Date: September 11th, 2024

Project: All Seasons Arena Renovation	City Project No.: 11075 State Project No.:
Contractor: Met-Con Construction	Date of Contract:

Description: Change Order 006 –

C0-21

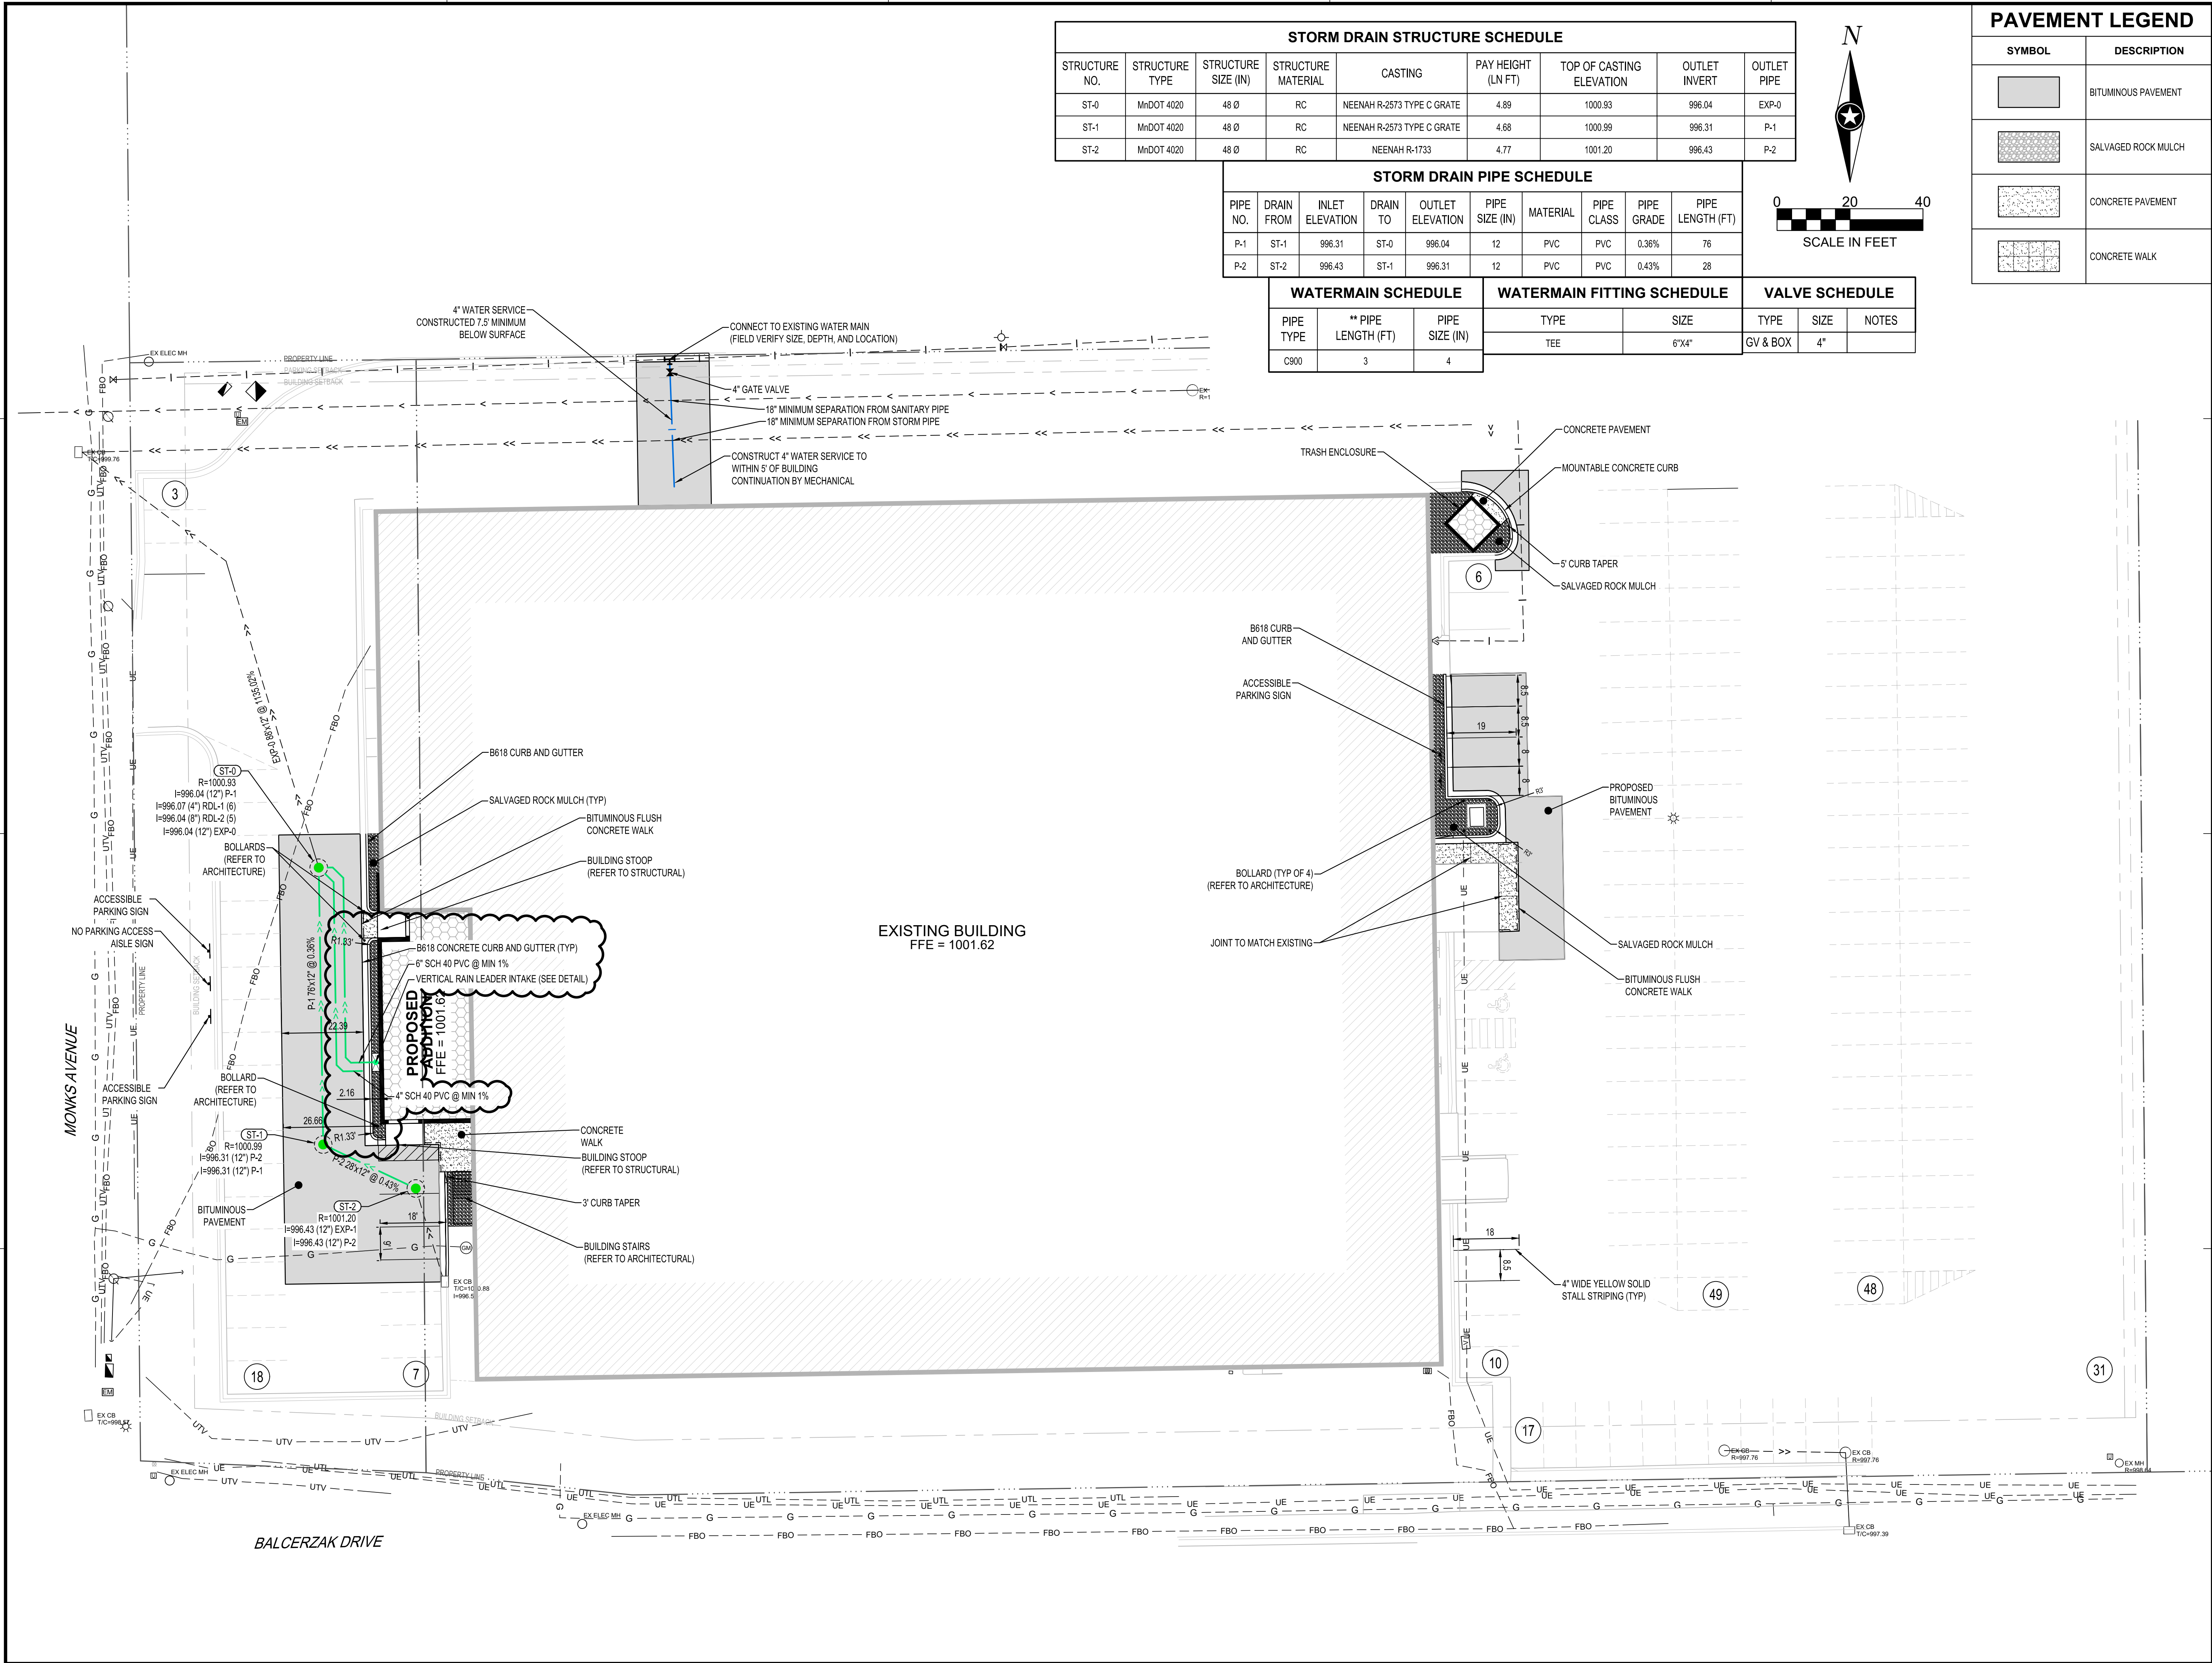
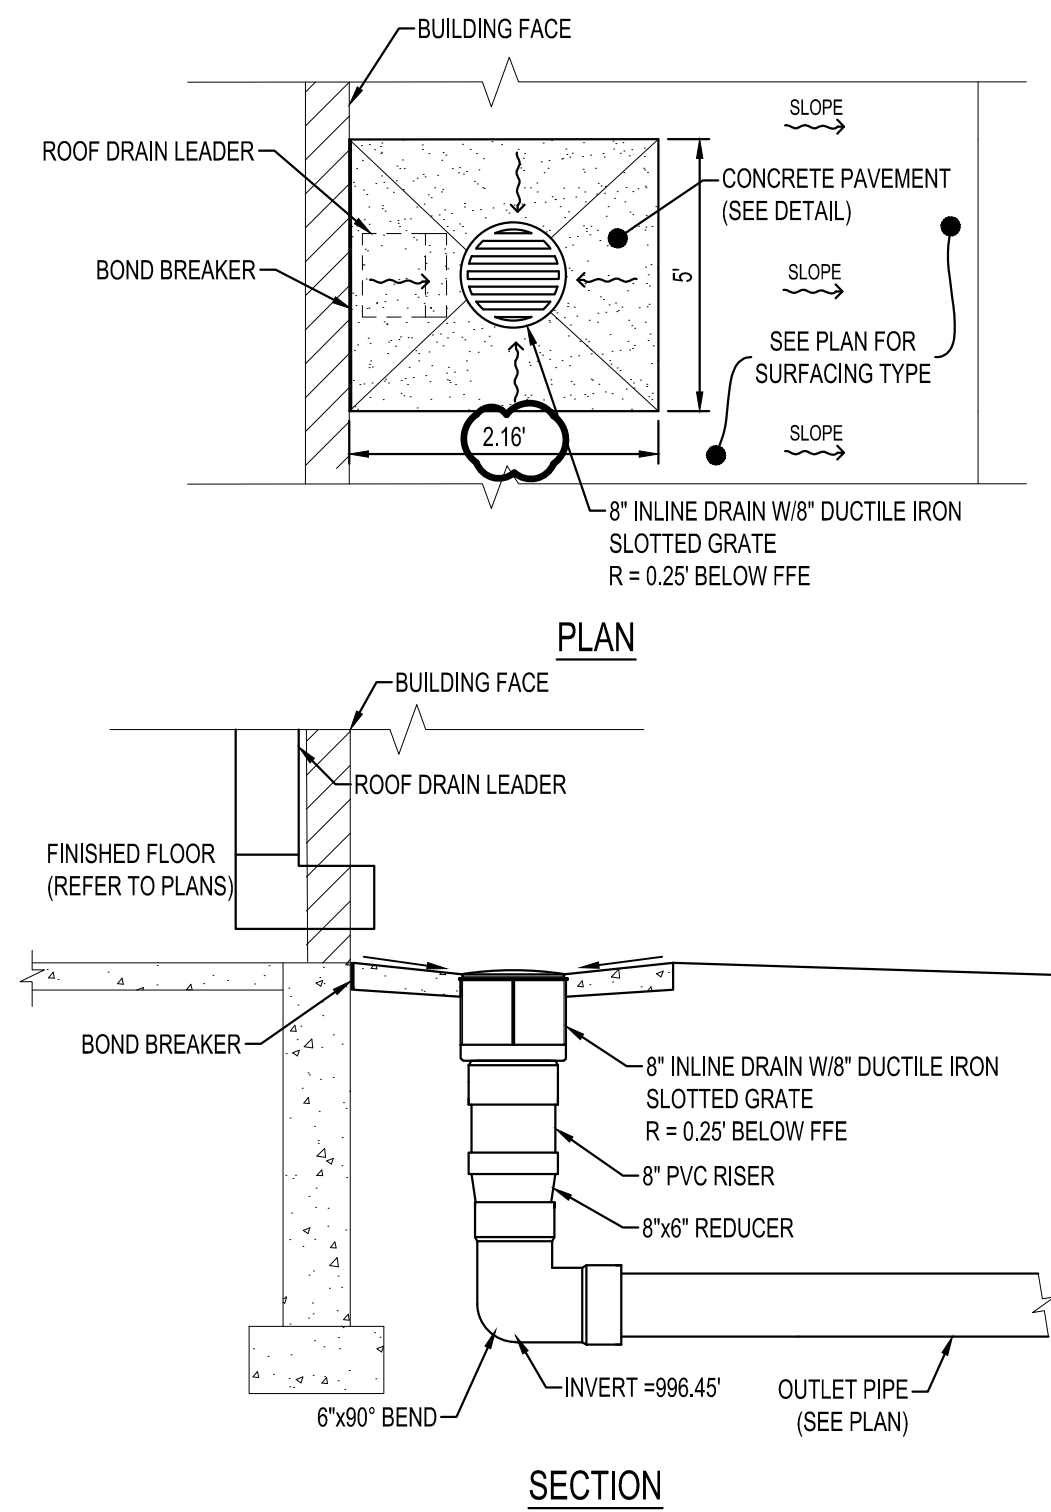
1. Refer to revised Plan Sheet C0-21 – SITE DETAILS
 - a. Revised the Vertical Rain Leader Intake Detail
2. Refer to revised Plan Sheet C3-11 – SITE AND UTILITY PLAN

SHEET
A1-31C

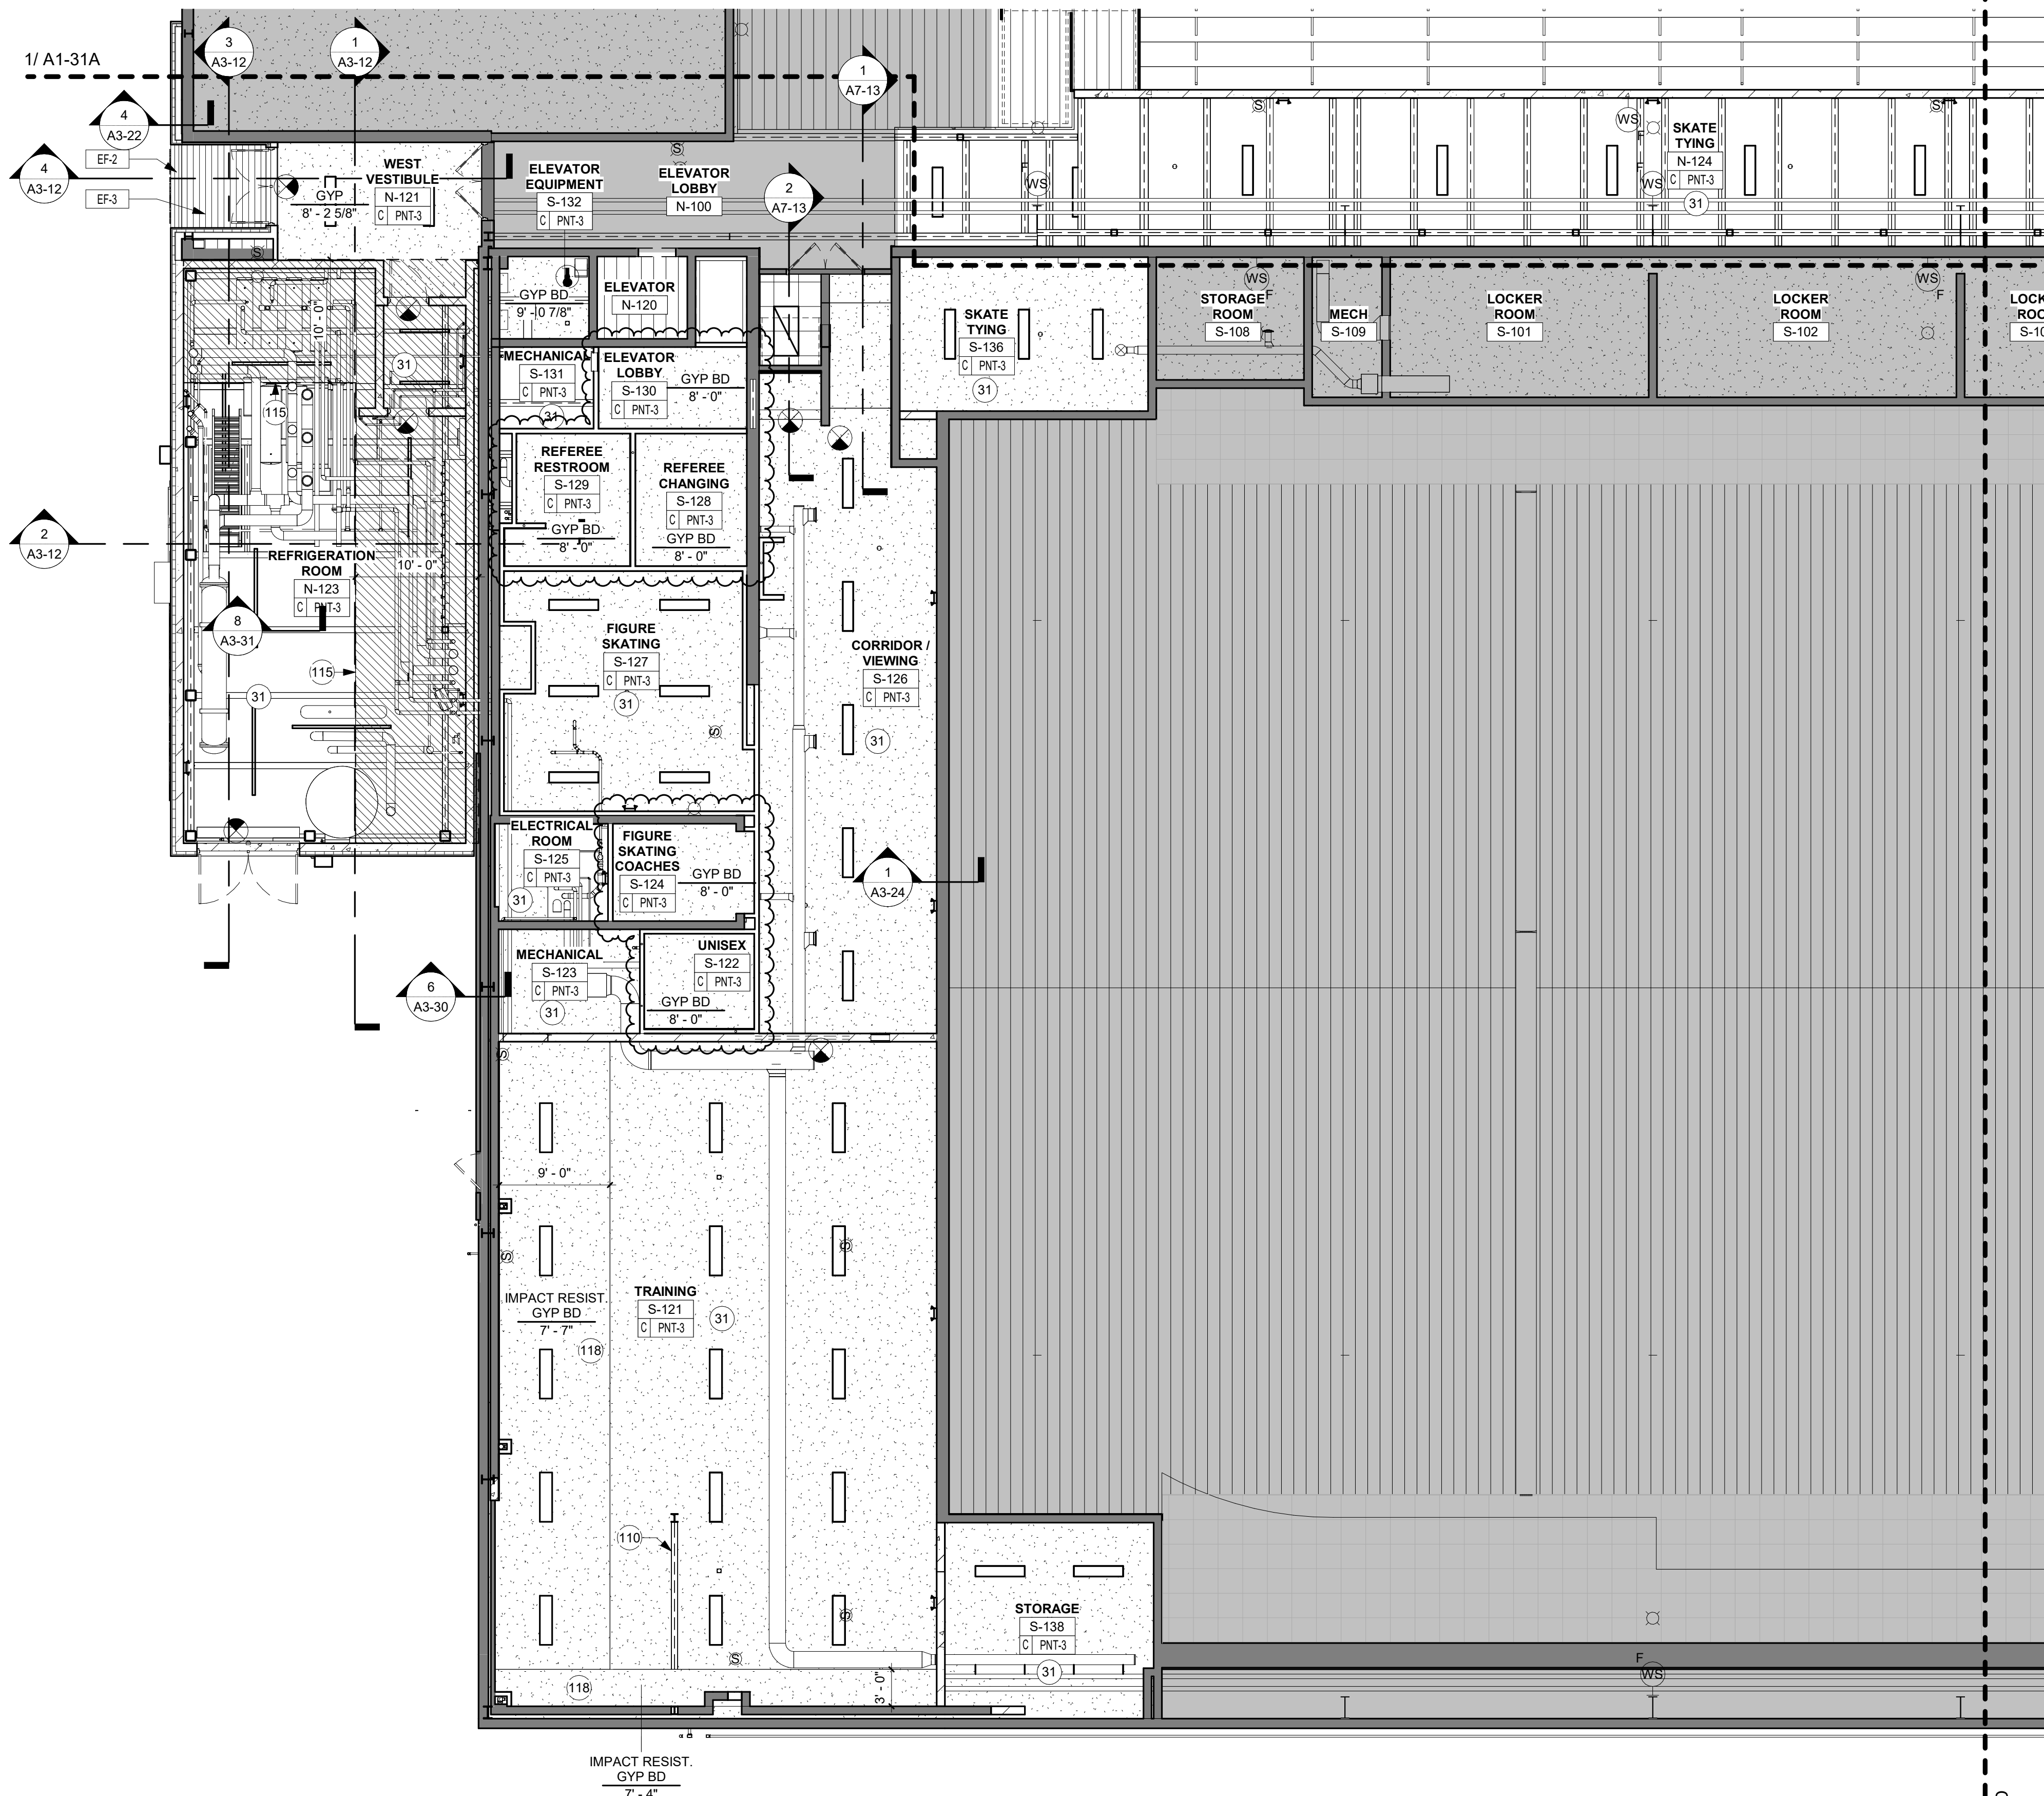
3. Refer to revised Plan Sheet C4-10 – SITE GRADING PLAN
 - a. Added spot elevations to B618 concrete curb and gutter
4. Refer to revised Plan Sheet A1-31C – FIRST FLOOR REFLECTED CEILING PLAN – AREA C

- a. Revised ceilings to be 8'-0" elevation in rooms: S-122, S-124, S-128, S-129, S-130
5. Refer to revised Plan Sheet P2-10C – FOUNDATION PLUMBING PLAN AREA C
